**UT to Town Creek Restoration Project – Option A
Year 2 Monitoring Report**

DMS Project ID Number – 94648; NC DEQ Contract No. 003277

Subject: Task 8: Annual Final Monitoring Report – Monitoring Year 2 & Response to Comments
UT to Town Creek Restoration Project – Option A
Yadkin River Basin – CU# 03040105 – Stanly County, NC
NCDMS Project ID No. 94648; NCDEQ Contract No. 003277

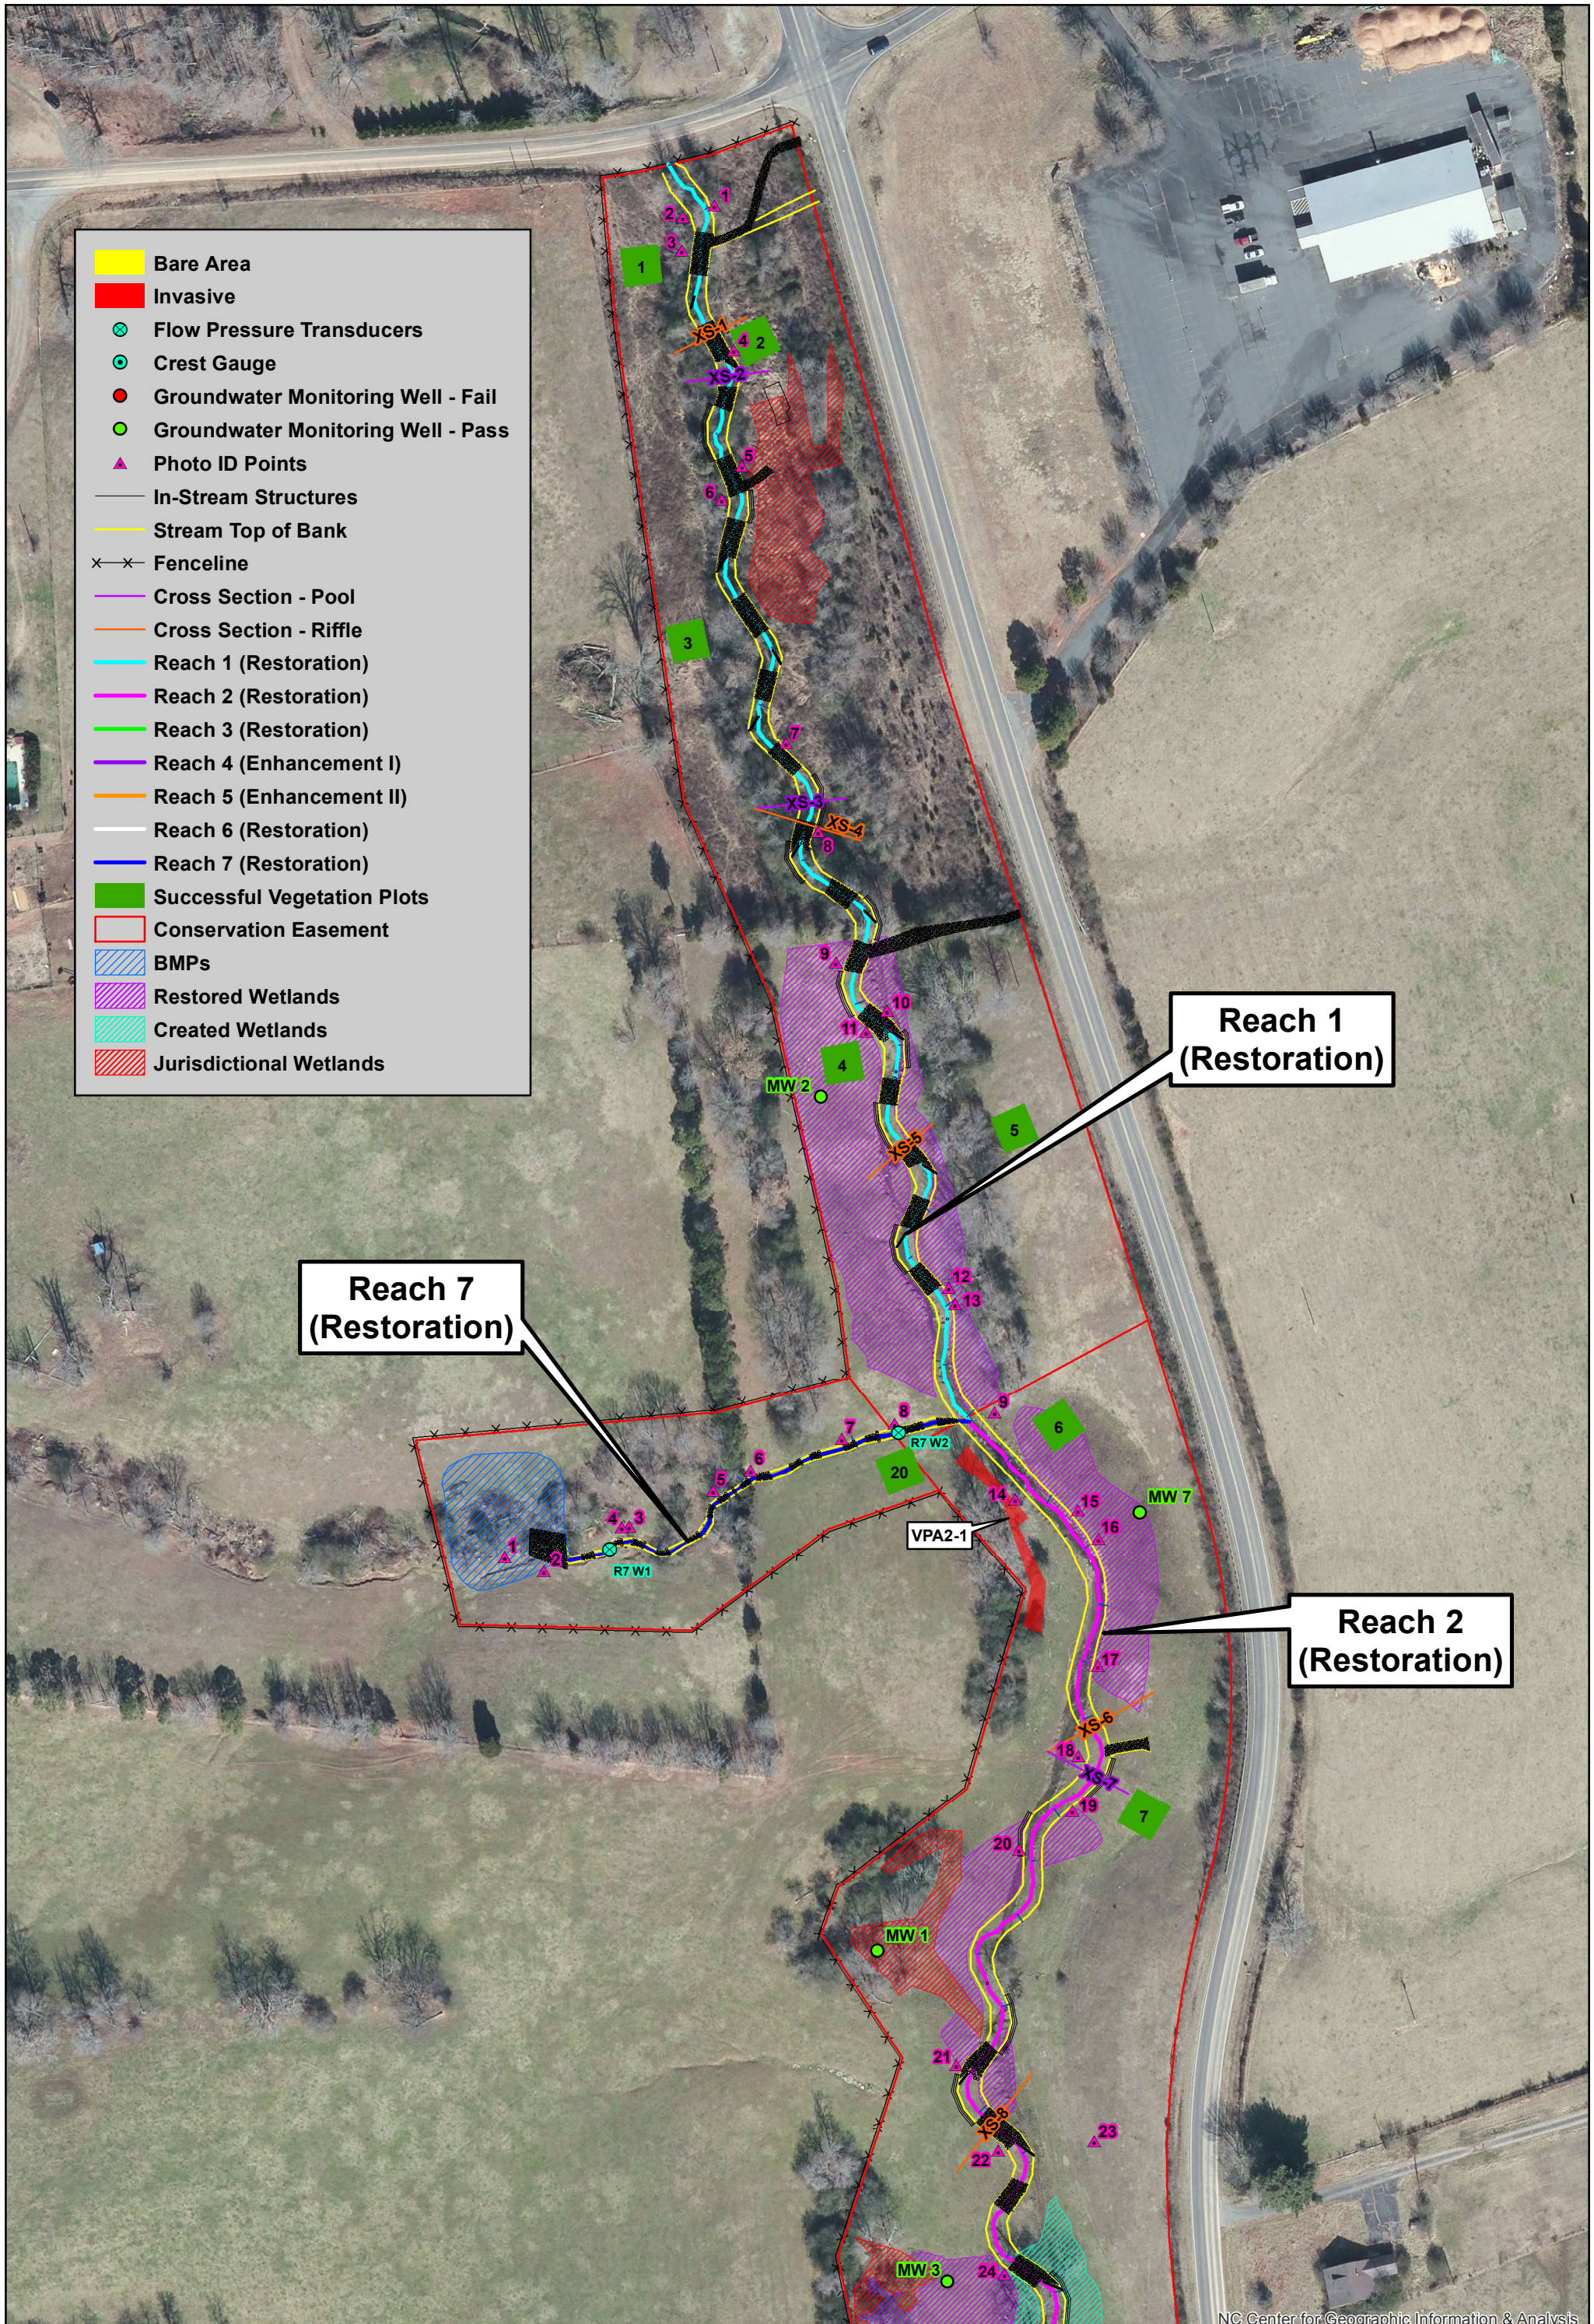
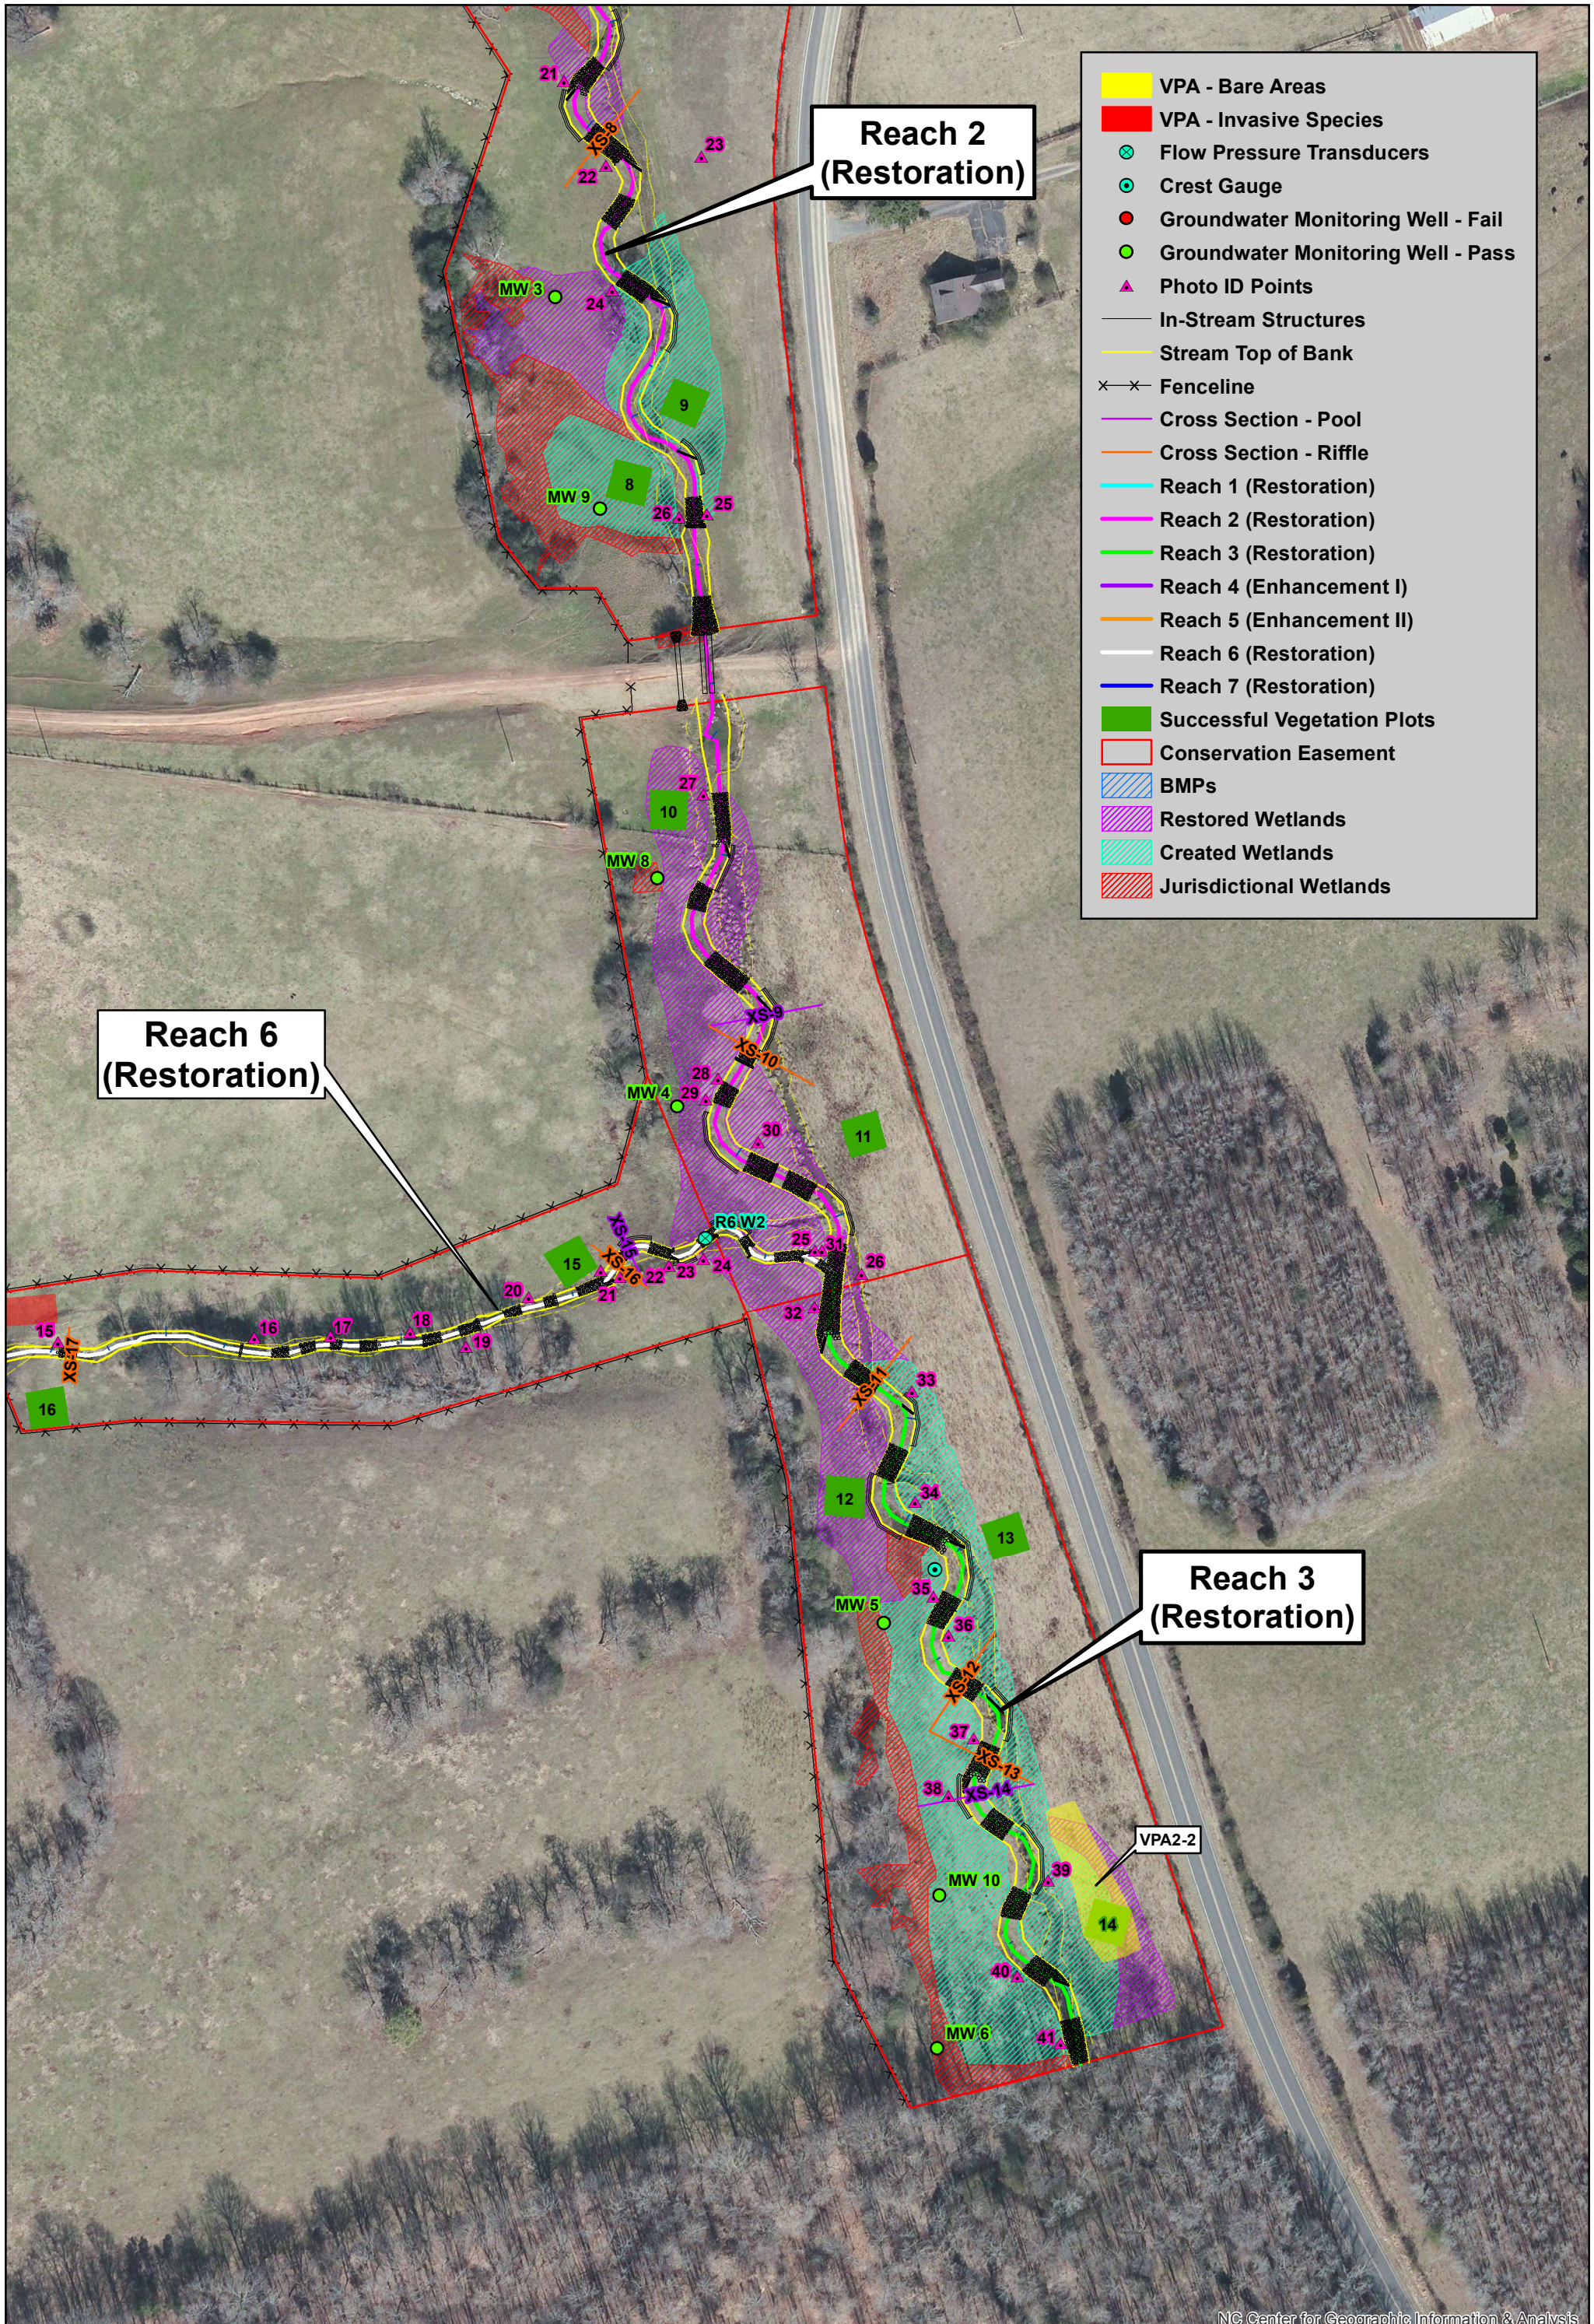
Figures 2a through 2c - Figures should be printed on 11x17 as they were in the MY01 report. Project monitoring features are not legible at the submitted print size / scale.

It would be preferable to show the stream segment for each asset type in a unique color rather than callouts to be consistent with most DMS monitoring reports. If that is not possible please show the reach breaks clearly. For example, Figure 2B shows point-callouts for Reach 2 and Reach 3 but it is not clear looking at the figure where the break point is between Reaches 2 and 3; e.g., is it the roadway/culvert or the confluence with Reach 6?

Response – Figures 2 – 2c have been printed on 11x17 sized paper. As requested, each reach has been identified with a distinct color to clearly define the reach on the CCPV maps (Figures 2 – 2C)
